# **Landscape Referral Response**

Application Number:	DA2025/0151
Date:	24/07/2025
Proposed Development:	Use of a tenancy in approved mixed use and seniors housing development as a centre-based child care facility including internal fit-out and landscaping
Responsible Officer:	Thomas Burns
Land to be developed (Address):	Lot 11 DP 1258355 , 5 Skyline Place FRENCHS FOREST NSW 2086

## Amended Plans Comment 24/07/2025

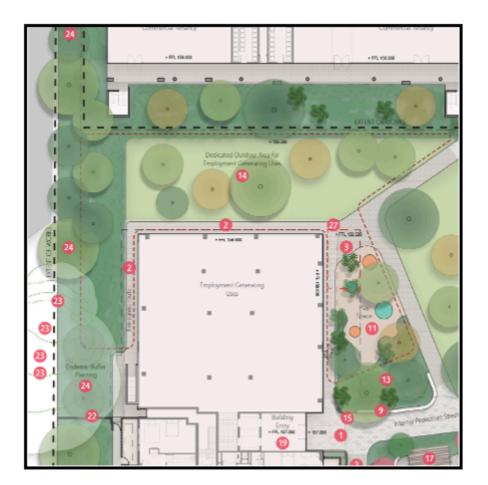
Review of the more detailed plans provided indicate that the use of the land as part of the child care centre operational requirements reduces the ability for tall tree planting.

The Landscape Plans provided indicate that only mid-sized trees can be provided to the perimeter of the area as opposed to tall canopy trees indicated on the original consent.

Use of the land as a childcare centre with the required outdoor play spaces restricts planting to the perimeter. Given that restriction, species proposed are appropriate for the available space.

Conditions have been provided if the proposal is to be approved.

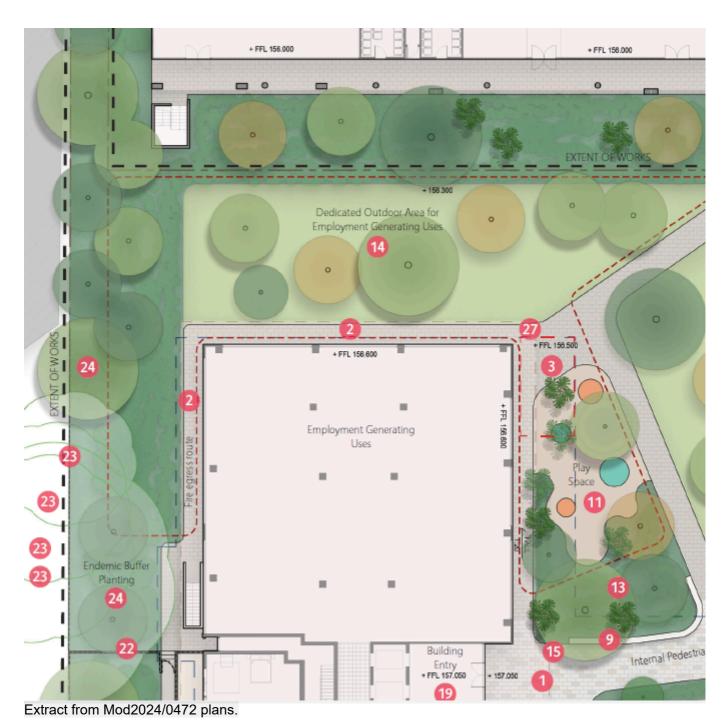
The proposal seems to indicate that soft landscape open space areas are being included in the play areas for the childcare centre.

Based on the minimal information provided, this would remove a number of replacement trees and lead to an apparent reduction in the provision of buildings in a landscape setting that is part of the current approval.

Landscape Plans are required to enable assessment of these changes.
